HISTORIC LANDMARK COMMISSION
PERMITS IN NATIONAL REGISTER HISTORIC DISTRICTS
SEPTEMBER 24, 2012
NRD-2012-0093
416 East 6th Street
Sixth Street

Install a new metal guardrail at the parapet to extend the roof deck.

○ Proposed
Guardrail around HVAC

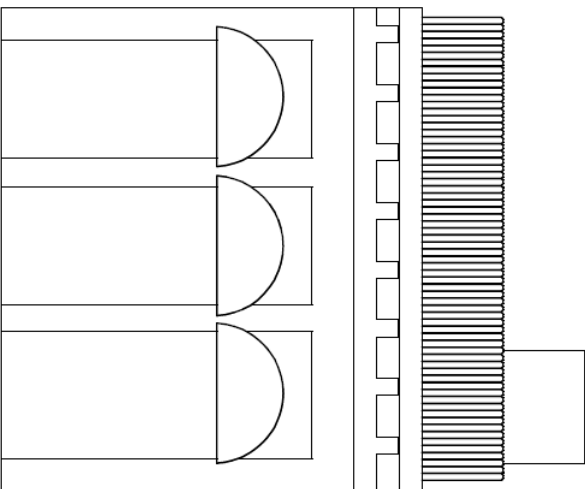
At the July, 2012 HLC meeting, staff recommended denial of the permit and asked that the applicant consider alternatives to their current plans. While the applicant has explored ways to hide or move the air conditioning unit, there do not appear to be any feasible or prudent alternatives to the current proposal. However, the current proposal violates the Sixth Street Architectural Design Guidelines as well as the approved policy statements of the Downtown Austin Plan, so staff must still oppose approval of the applicant's proposal.

Staff recommends denial of the application, although staff is sympathetic with the applicant, who is seeking to improve an eye-sore on the roof of the building by hiding an air conditioning unit. However, while staff appreciates the applicant's efforts, his proposal violates the Sixth Street Architectural Design Guidelines and the confirmation thereof by the Downtown Austin Plan, so staff cannot recommend approval of the application.
